UNITED STATES PATENT AND TRADEMARK OFFICE

10/811,055

Office Action Summary

DETAILED ACTION

Fig. 1.

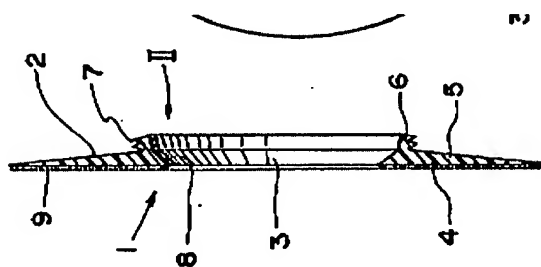
Regarding claims 35, 59 and 60, McDonnell teaches a device (10) capable of sealing a stoma, said device (10) being situated entirely externally to the body and comprising recess defining means (15); means (1) capable of securing said recess defining means (15) to the body proximate the stoma; and means (16) capable of covering a stoma, situated within said recess

defining means (15), and comprising a continuous, uninterrupted member that in combination with recess defining means (15) is capable of preventing liquid and/or solid material from exiting the stoma, said recess defining means (15) defining, with said stoma covering means (16), a chamber (17a), said chamber (17a) being situated over said stoma covering means (16) and pressurizable (cap (15) may be pressed by hand) to press said stoma covering means (16) against a stoma (see figure 1 & 3, *infra*).

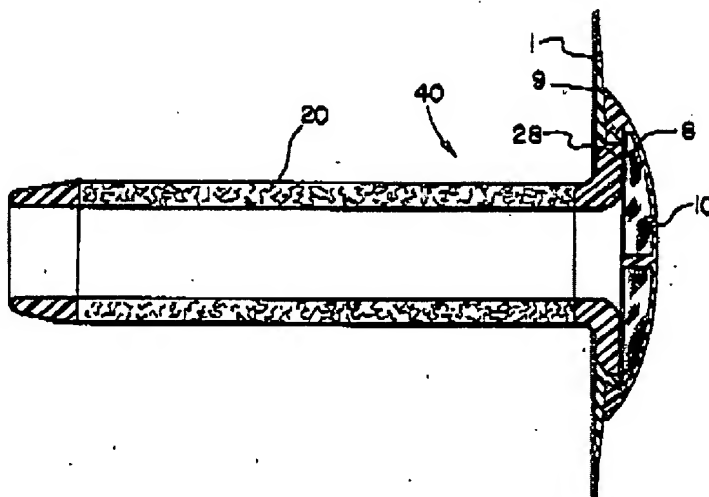
Regarding claim 47, McDonnell teaches venting means (19) in said recess defining means (15).

FIG. 5

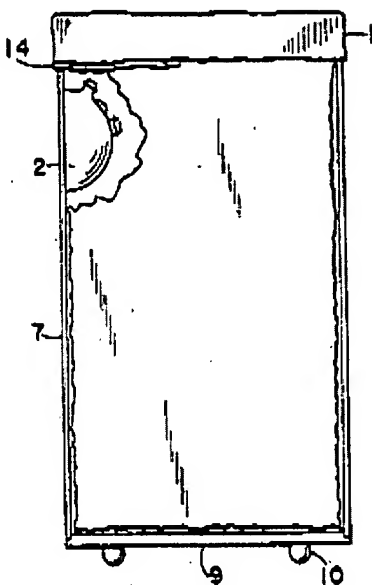
Cornwell teaches an elongated, collapsible pouch (1) for disposing of infectious medical wastes (see fig. 5, *infra*).

At the time of the invention, it would have been obvious for one of ordinary skill in the art to use the medical waste pouch of Cornwell to dispose of the device of McDonnell in order to provide a means of safely disposing of the device after use.

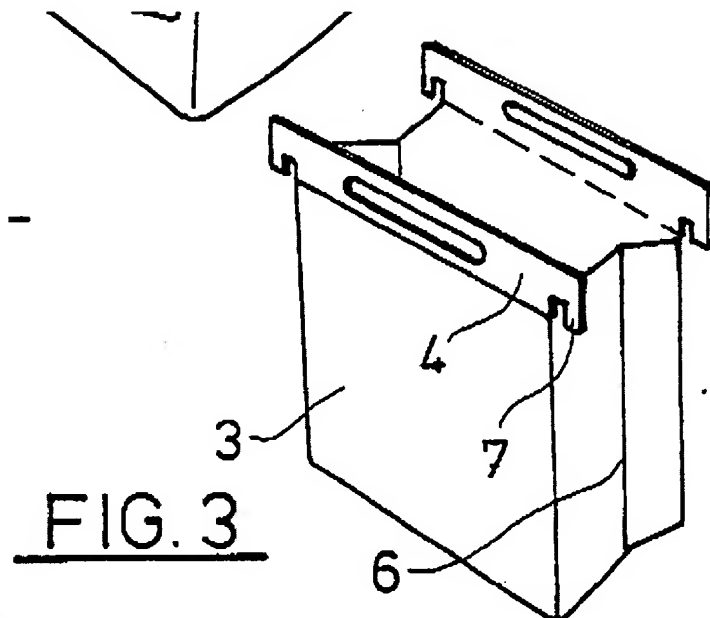
Bergmann teaches a waste bag (4) having a concertina configuration (see English language abstract)(see fig. 3, *infra*).

At the time of the invention, it would have been obvious for one of ordinary skill in the art to use the medical waste pouch of Bergmann to dispose of the device of McDonnell in order to provide a means of conveniently disposing of the device after use.

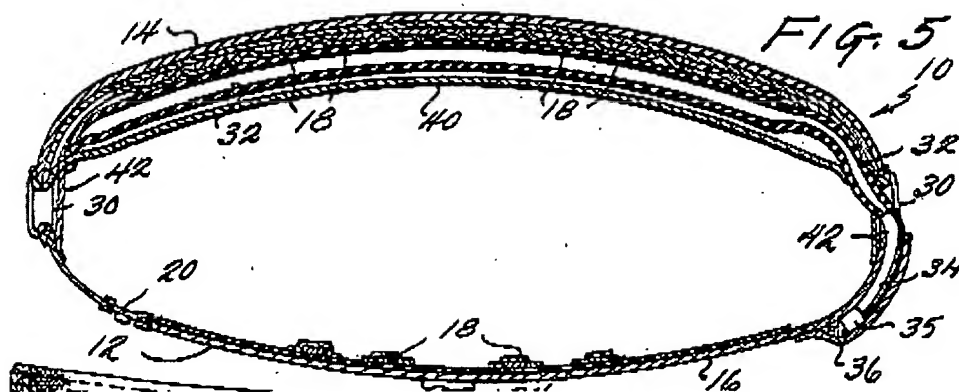
Regarding claims 35, 59 and 60, Eisen teaches a device (10) capable of sealing a stoma, said device (10) being situated entirely externally to the body and comprising recess defining means (14); means (30, 42) capable of securing said recess defining means (14) to the body proximate the stoma; and means (inner or body-facing layer of bladder (32) and liner (40)) capable of covering a stoma, situated within said recess defining means (14), and comprising a continuous, uninterrupted member (inner layer of bladder (32) and liner (40)) that is capable of occluding a stoma when it is pressed against a stoma, said recess defining means (14) defining, with said stoma covering means, a chamber (32), said chamber being situated over said stoma

covering means and pressurizable to press said stoma covering means against a stoma (1)(col. 1, line 66-col. 2, line 25)(see figure 5, infra).

Regarding claim 37, Eisen teaches that bladder (32) bodyside layer and liner (40) are fixed to the interior of recess defining means (14)(see fig. 5, supra).

Regarding claim 57, Eisen teaches a pouch (40) having ends fixed between recess defining means (14) and securing means (30)(see fig. 5).

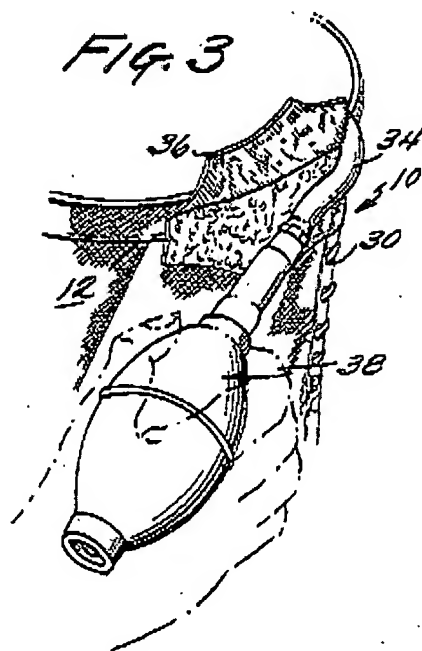
Schrieber teaches a belt with inflatable bladder (14) that is made of rubber such that it inherently impervious to gases in addition to solid or liquid human wastes (col. 2, lines 40-51).

At the time of the invention, it would have been obvious to one of ordinary skill in the art to make Eisen’s bladder walls out of the rubber material taught by Schrieber in order to provide materials that are known in the art to be gas impervious so that the bladder can retain an inflated configuration.

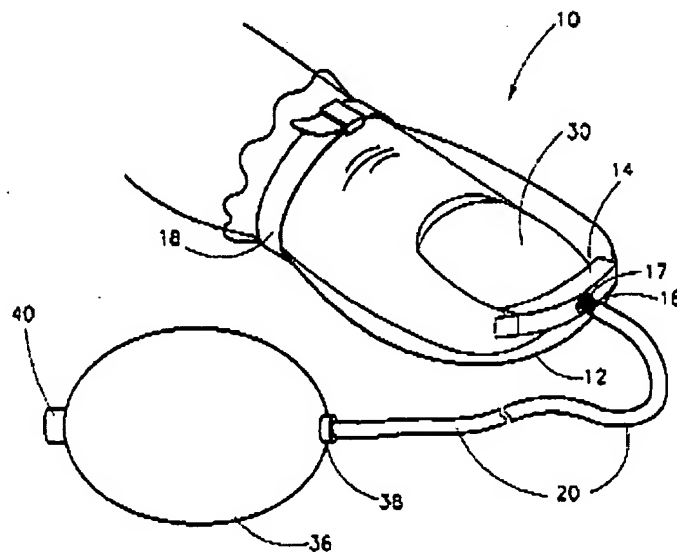
Berenstein teaches a handpump (40) that is flexible so as to allow it to pump air (col. 3, lines 9-19)(see fig. 1, infra).

At the time of the invention, it would have been obvious to one of ordinary skill in the art to make the pump of Eisen and Schrieber flexible in the manner taught by Berenstein in order to provide a manual pump that is recognized in the art as being suitable for pumping air to a wearable article.
